8 Well Name and No
SKELLY UNIT #944 (29742)

9 API Well No
30-015-32963

13 Describe Proposed or Completed Operation. Clearly state all pertinent details, including estimated starting date of any proposed work and approximate duration thereof. If the proposal is to deepen directionally or recompleat horizontally, give subsurface locations and measured and true vertical depths of all pertinent markers and zones. Attach the Bond under which the work will be performed or provide the Bond No. on file with BLM/BIA. Required subsequent reports must be filed within 30 days following completion of the involved operations. If the operation results in a multiple completion or recompleat in a new interval, a Form 3160-4 must be filed once testing has been completed. Final Abandonment Notices must be filed only after all requirements, including reclamation, have been completed and the operator has determined that the site is ready for final inspection.)

Skelly Unit #944
Chevron / COG Operating LLC
30-015-32963
June 21, 2011
Conditions of Approval

12. Summary Drilling and Completion Program

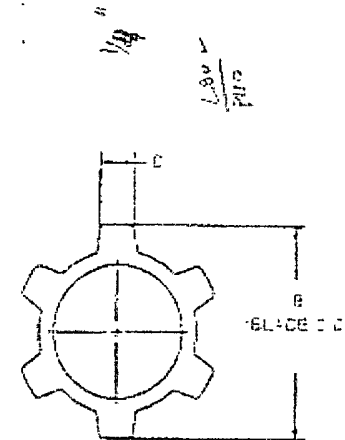
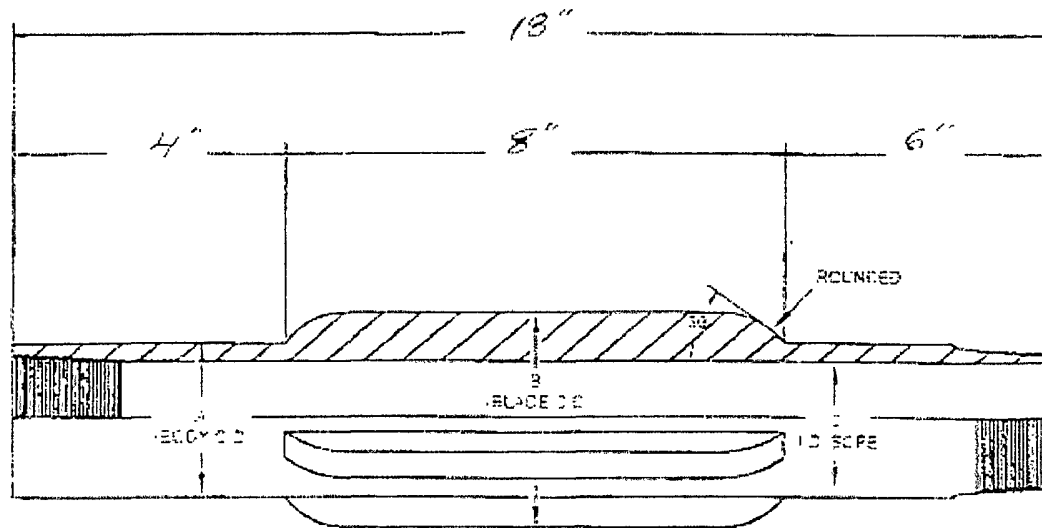
- f) The planned depth for setting the DV tool should be revised to $\pm 4831'$, or shallower; which is above the top of the open perforations to be squeezed. By doing so, all of the squeezed perforations will be cemented behind the 4" casing. When plugged, a cement plug will be required across this tieback.

- h) The 4" casing will be backed off above the DV tool, now being located at $\pm 4831'$.
- i) If cement does not circulate from DV tool, the appropriate BLM office is to be notified. In that event, Operator to recommend the alternate method of confirming TOC.
